### **Federal Aviation Administration**

**[Docket No. FAA-2022-1647; Project Identifier AD-2022-01379-T; Amendment 39-22438; AD 2023-10-02]**

### **Airworthiness Directives; Transport and Commuter Category Airplanes**

Final rule.

Figure 1 to paragraph (g)(1)(i)— *Fundamental Effective Isotropic PSD at Outside Interface of Airplane Antenna*

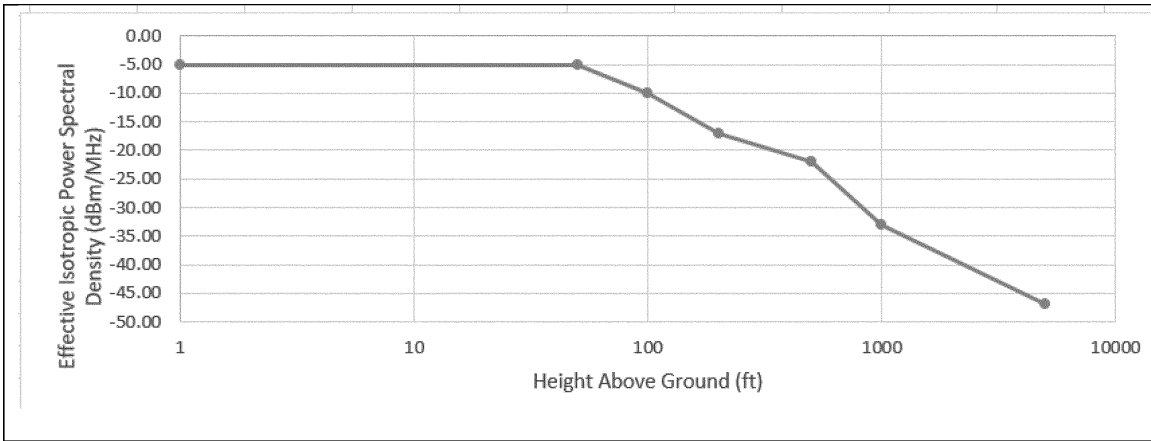
*Comment summary:* Textron Aviation requested the FAA clarify at what reference point the PSD requirements apply. The commenter stated it assumed that they apply at the radio altimeter receive antenna input, such that antenna characteristics, coax loss, and filter characteristics would be included in the determination.

*FAA response:* The FAA agrees and has changed the title of figure 1 to paragraph (g)(1)(i) of this AD to reflect that the PSD requirements apply at the antenna input to the radio altimeter, and that the figure applies to the outward facing side of the antenna.

*FAA response:* The FAA agrees and has changed paragraphs (g)(1)(i) and (ii) of this AD to include the applicable frequency bands.

Figure 2 to paragraph (g)(1)(ii)— *Spurious Effective Isotropic PSD at Outside Interface of Airplane Antenna*

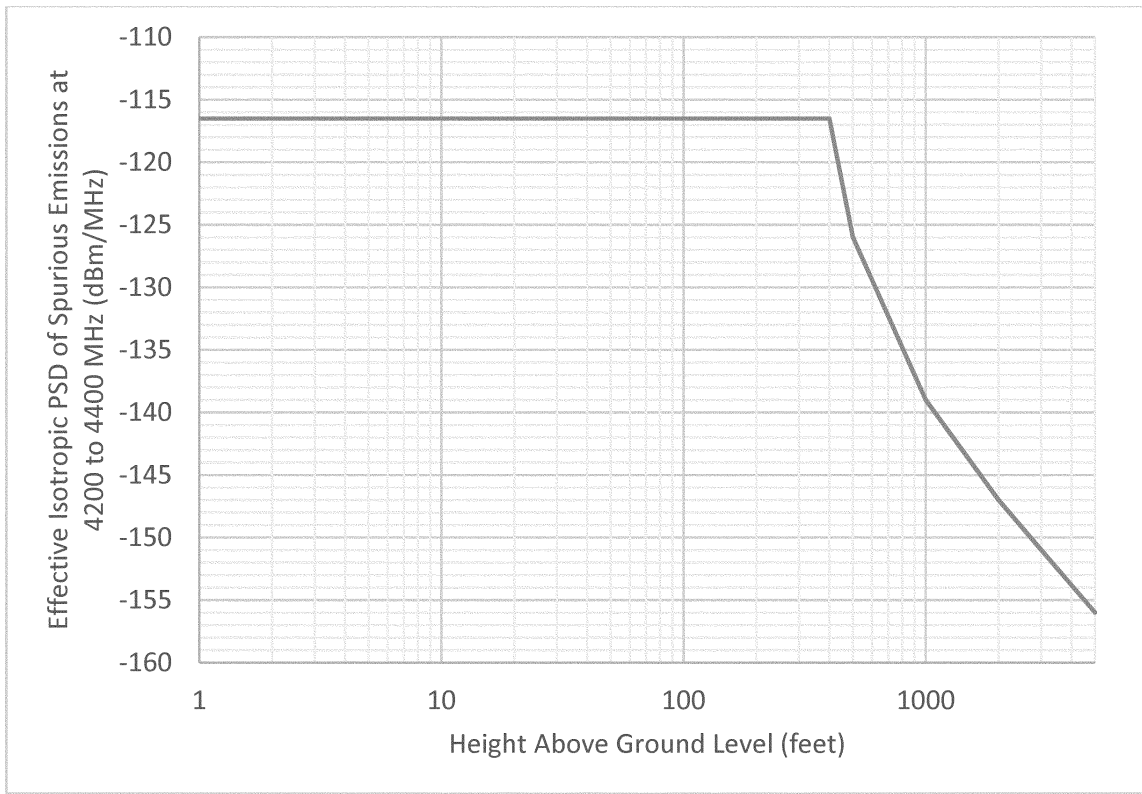
*Comment summary:* AIA requested that the FAA provide more information about the tolerances for determination of whether an airplane is radio altimeter tolerant. Several commenters requested that the FAA add a new figure indicating the spurious tolerance, similar to the figure with the PSD tolerance curve, and a specification of the altitude dependence for spurious tolerance.

*FAA response:* The FAA agrees and has replaced the proposed fixed emission level with a spurious PSD tolerance curve in figure 2 to paragraph (g)(1)(ii) of this AD. Subsequent figures have been redesignated accordingly.
